STOCKTON UNIFIED SCHOOL DISTRICT

Expanded Learning Opportunities Program (ELOP) - Relocatable Classroom Buildings

The following additions, deletions and revisions to the plans, specifications and Addenda shall become a part of the plans and specifications. It is the responsibility of the General Contractor to submit the information contained in this addendum to all subcontractors and suppliers. The Bidder shall acknowledge receipt of the Addendum in the Bid Proposal. (Addendum number of pages: **32** pages + **77** attachments = **109** total pages).

JOB NUMBER:
23-13018.00
 DWG. DATE:
02/20/25
 AD1-HAM-
 A202

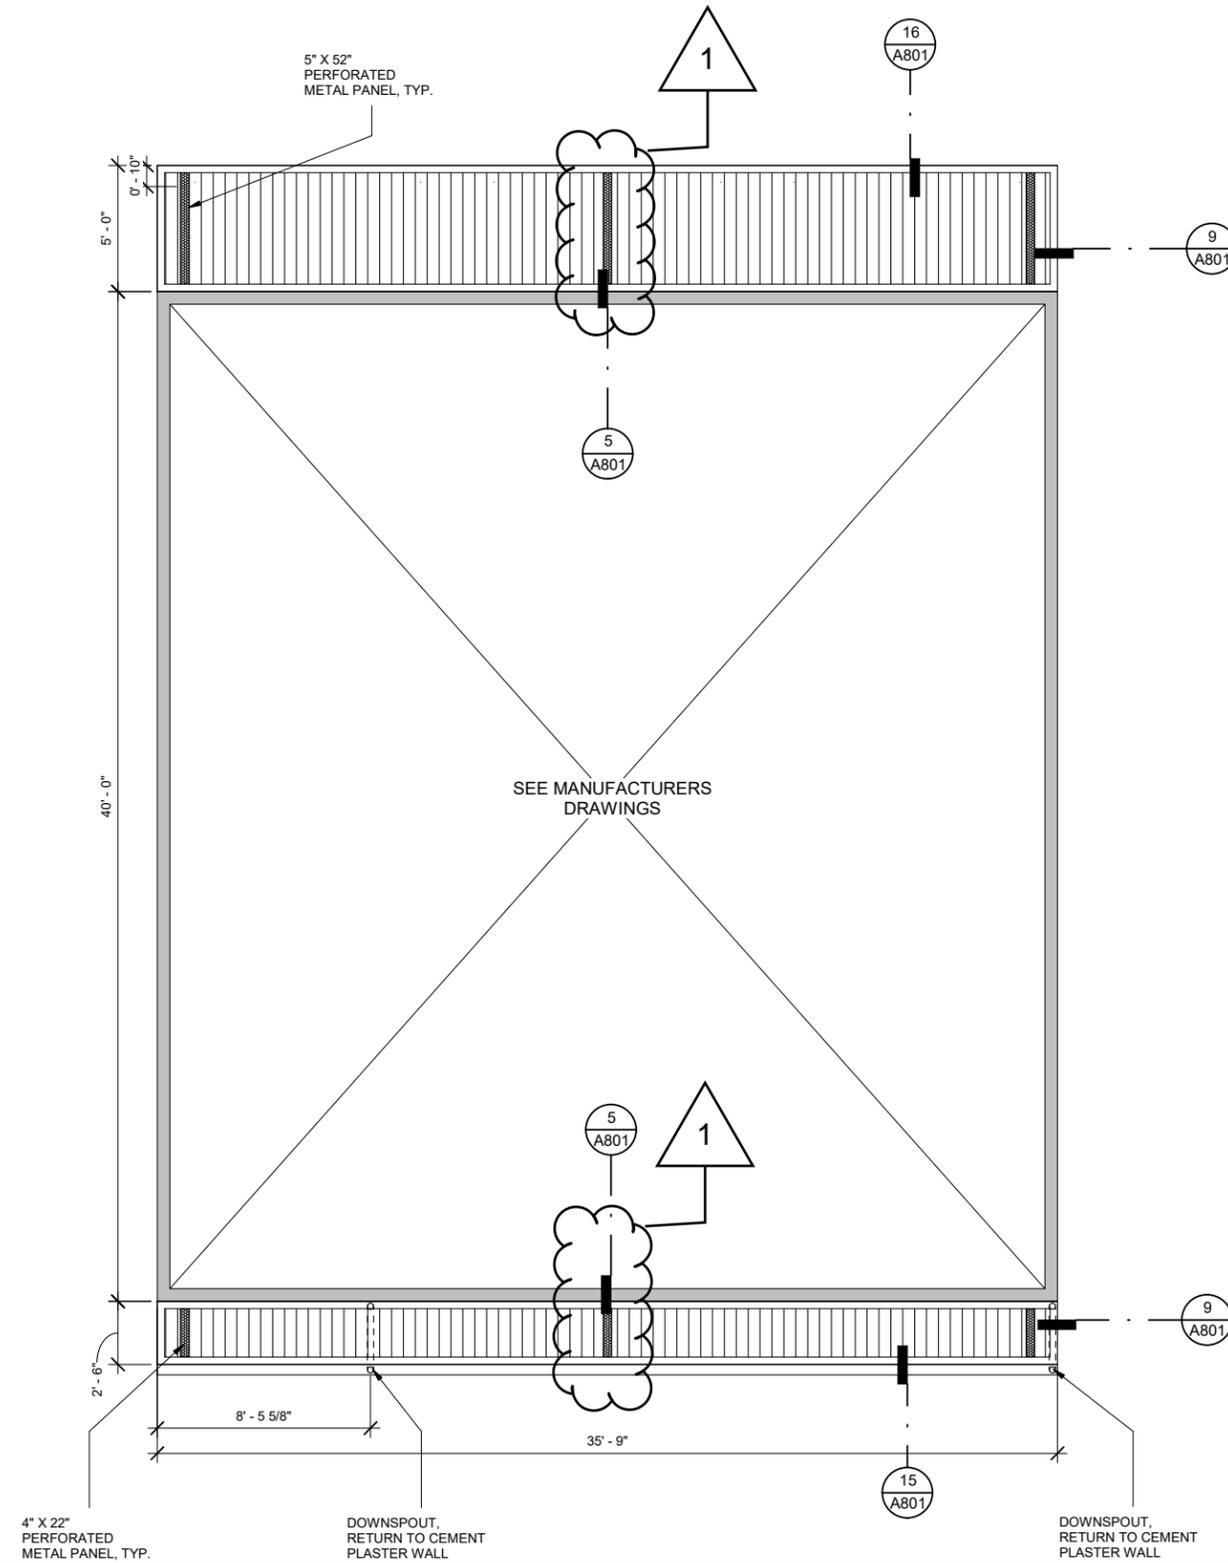
1 - 094: DRAWINGS SHEET A202 - “VENTING FLOOR PLANS”, revise as follows:

AD1-HAM-
A802

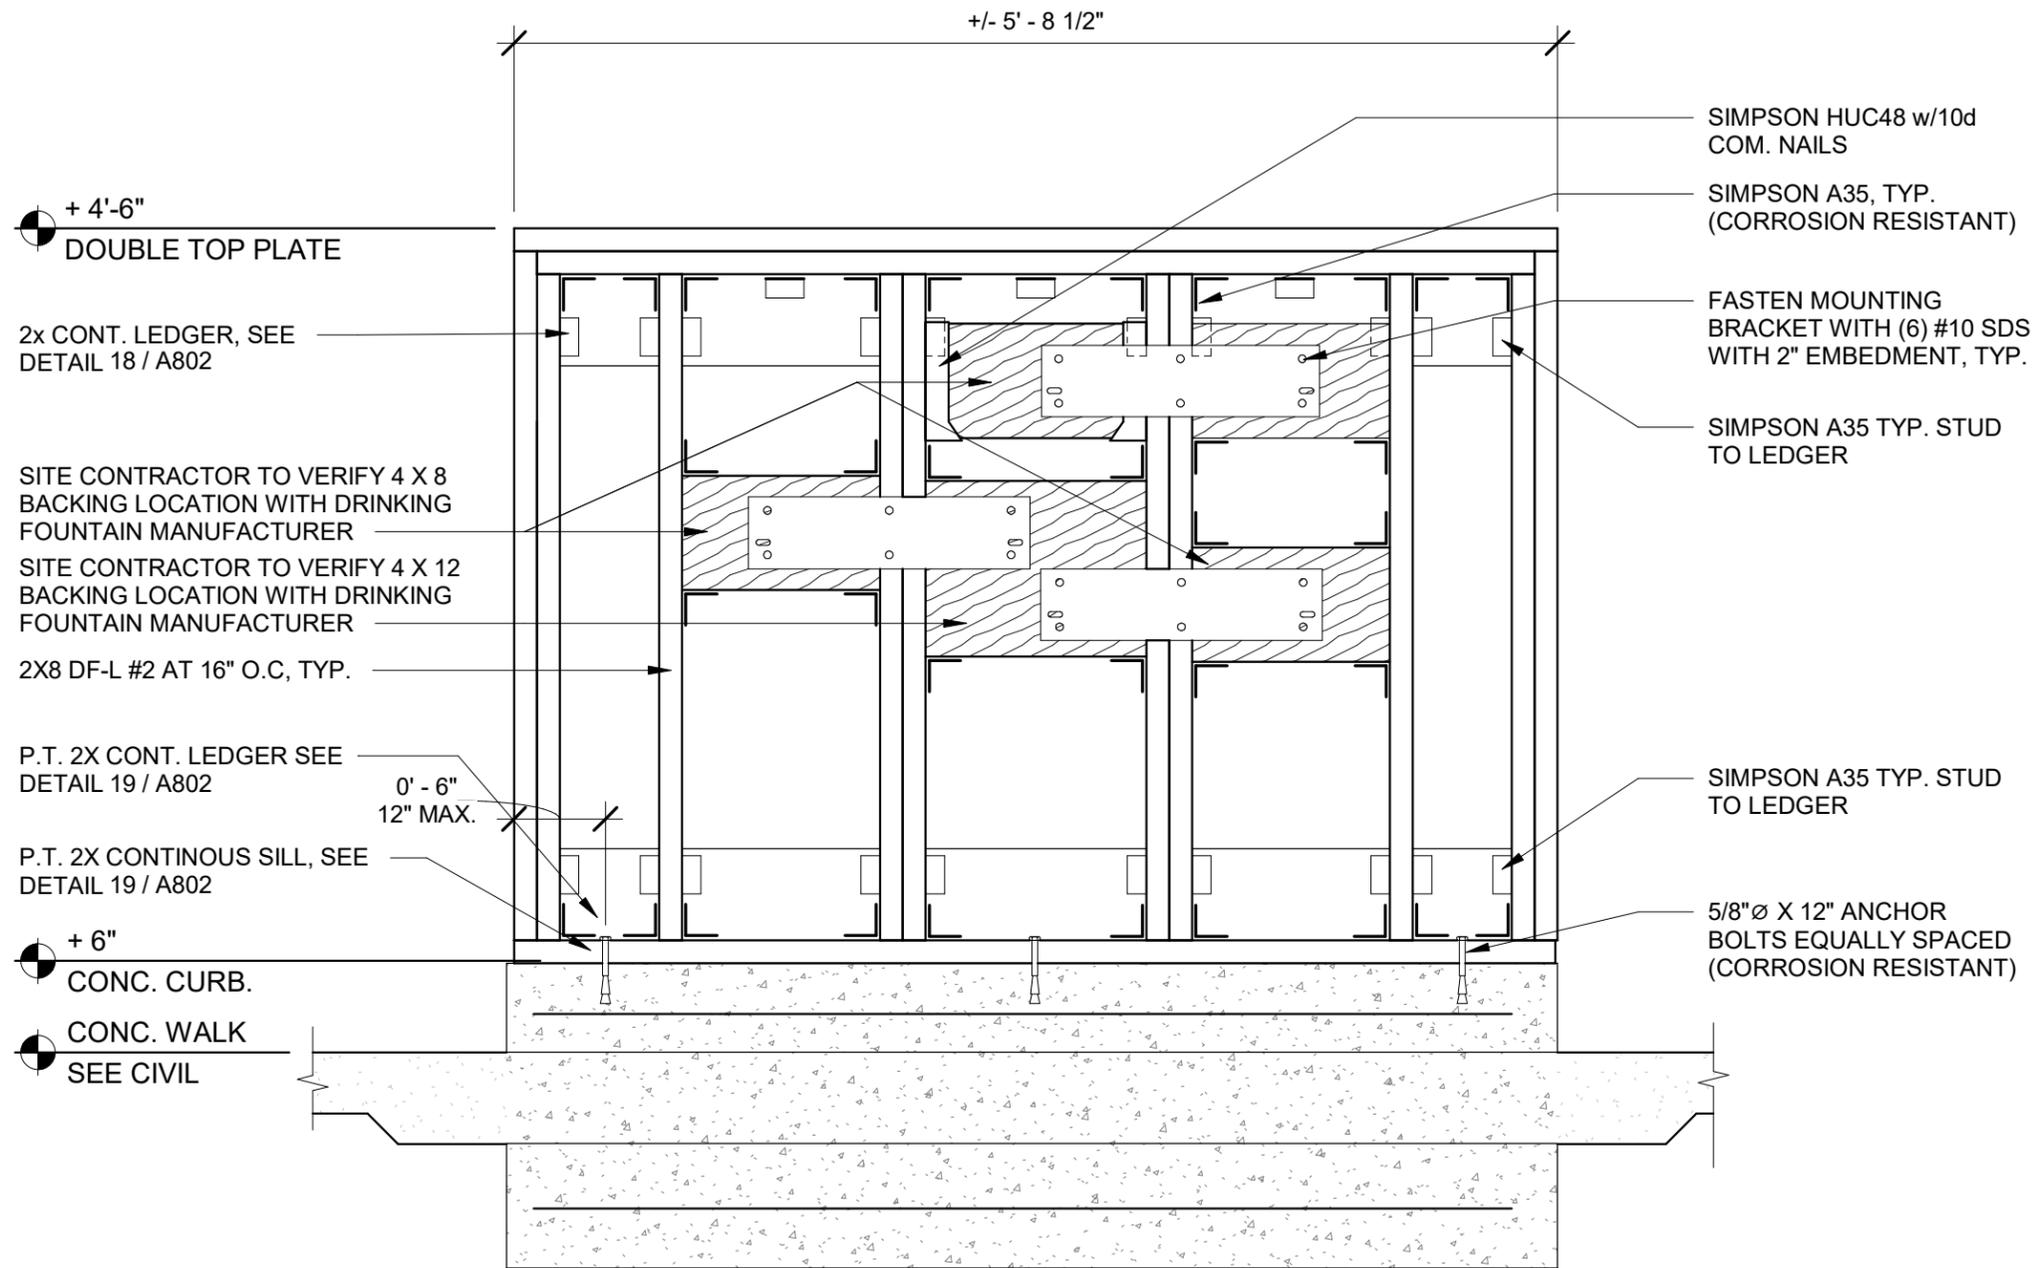
1 - 095: DRAWINGS, SHEET A802 – “EXTERIOR DETAILS”, revise as follows:

A. Detail 8 – Tile hatch pattern to be removed from elevation.

1. Detail 4 - Perforated metal panel has now been identified.
2. Detail 6 – Added additional A35.
